VWC3 Third Submittal Response

PROJECT: Village at Westerly Creek III (DA-1639-01, Case # 2009-4001-02)

Below are my responses to the Second Submission Development Review comments.

Re: Second Submission Review – Villages at Westerly Creek Phase 3 – Site Plan – Comment Response

SHEET TITLE: 1
BUILDING 03 NORTH AND SOUTH
ELEVATIONS

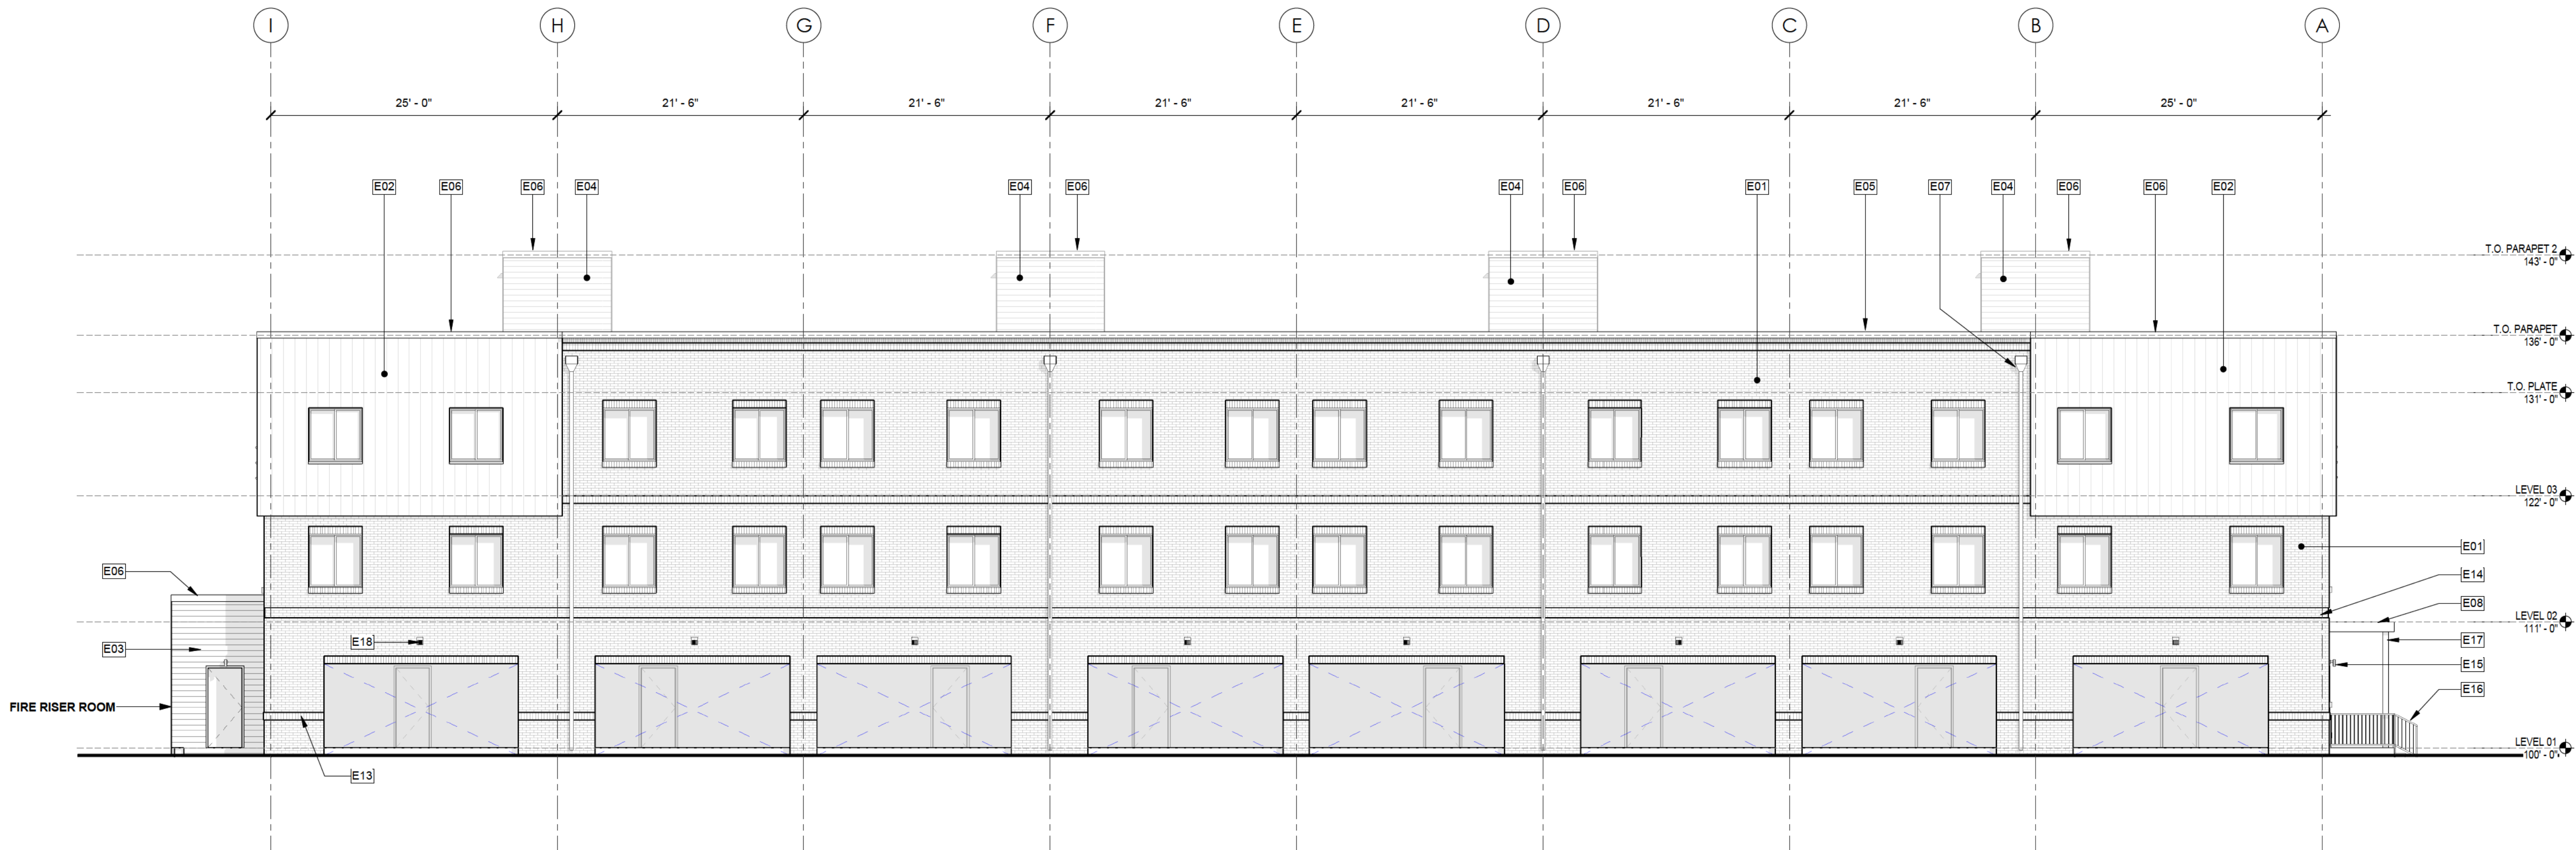
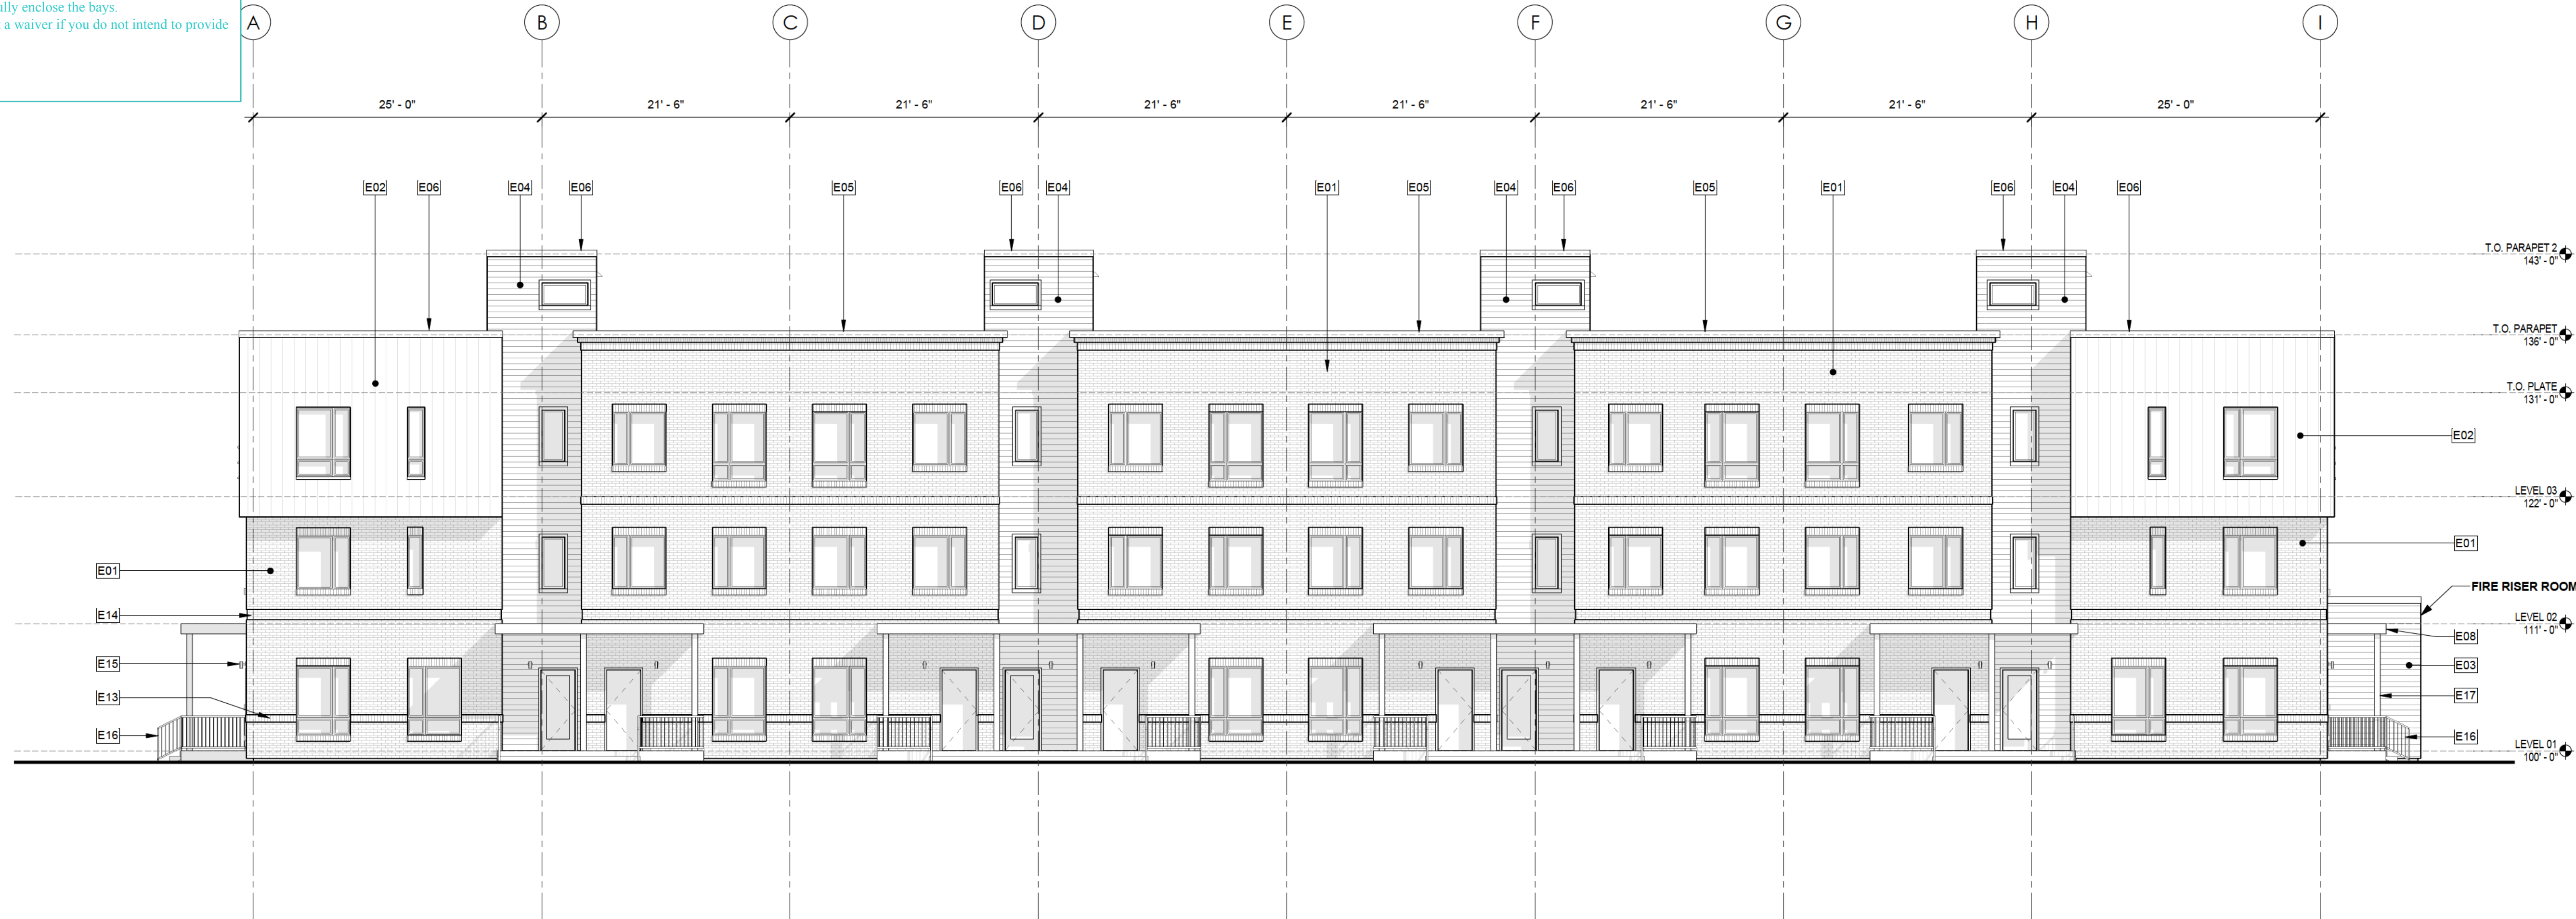
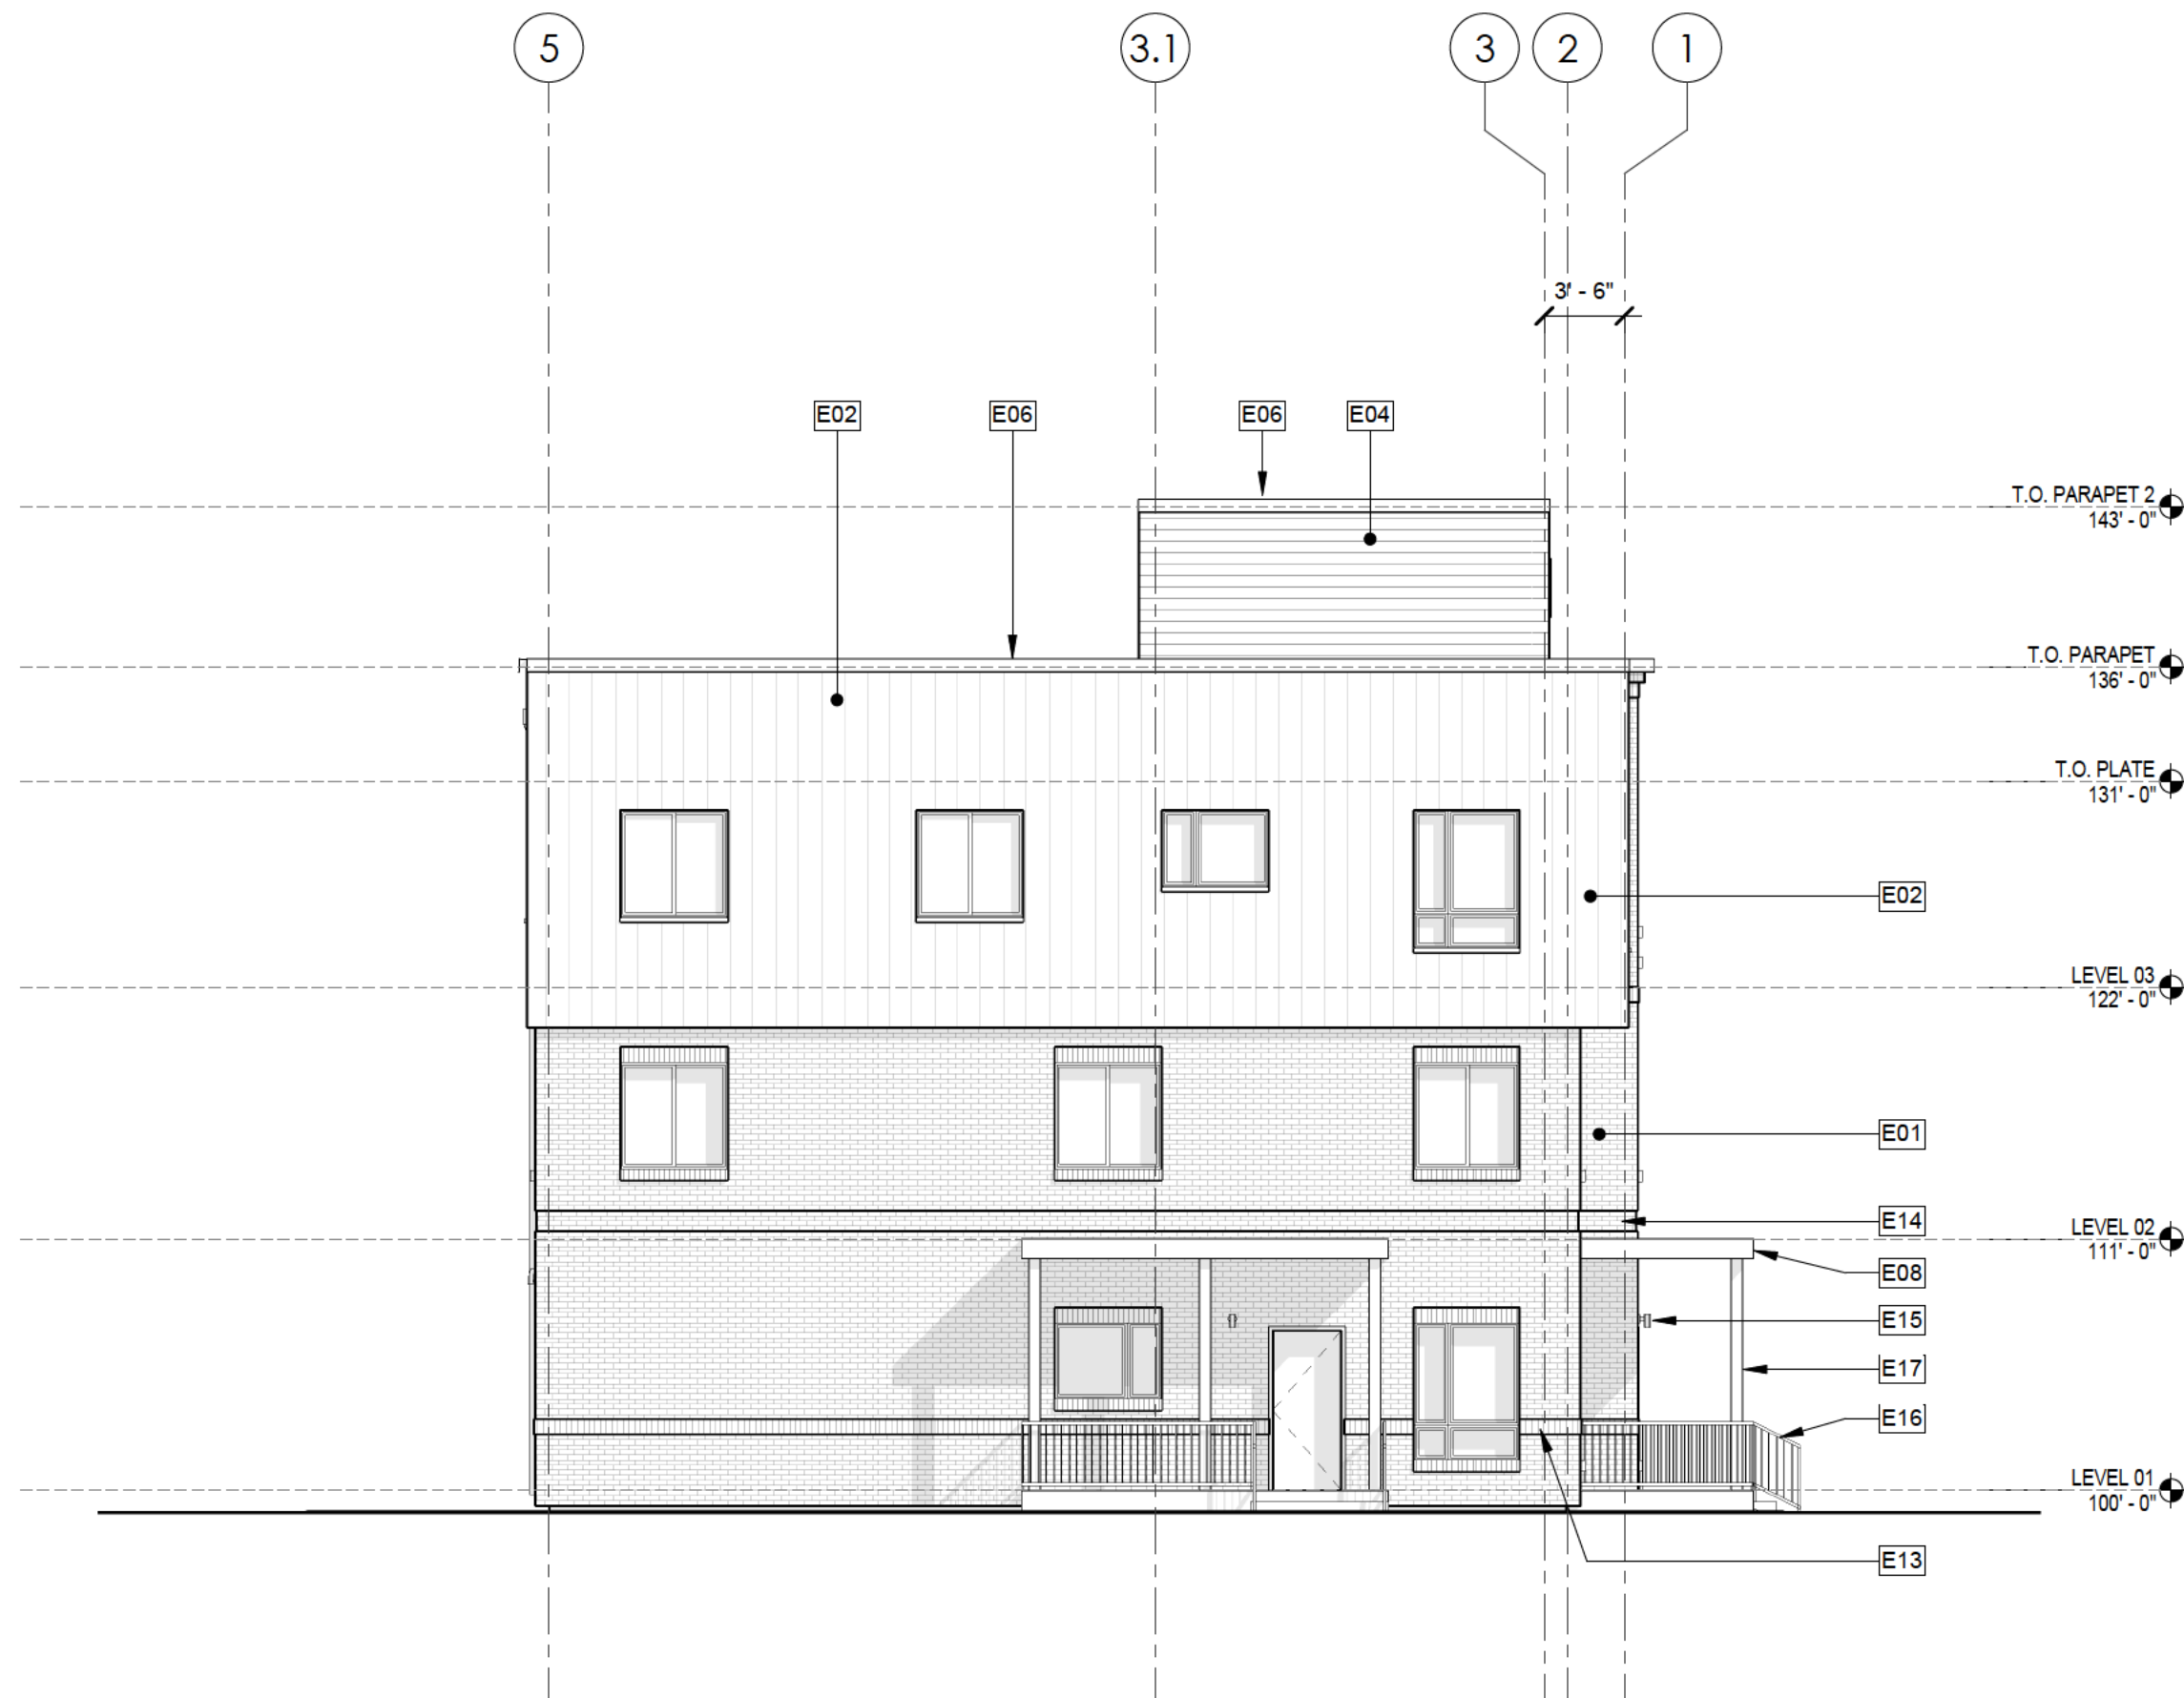
Section 146-1509 requires at least 35 percent of resident parking shall be in garages, and at least 50 percent of those garages to be attached to a residential structure. Per Article 20 of the Zoning Code, the definition of a garage is "a fully enclosed building with one or more vehicular doors for the parking or storage of motor vehicles". Please provide garage doors to fully enclose the bays. You must request a waiver if you do not intend to provide garage doors.

- B. A waiver to remove all garage doors has been requested.
 - C. Enhanced architectural details have been added to Building 9 in the form of colored metal panel and a split face architectural block wainscot around the entire building.
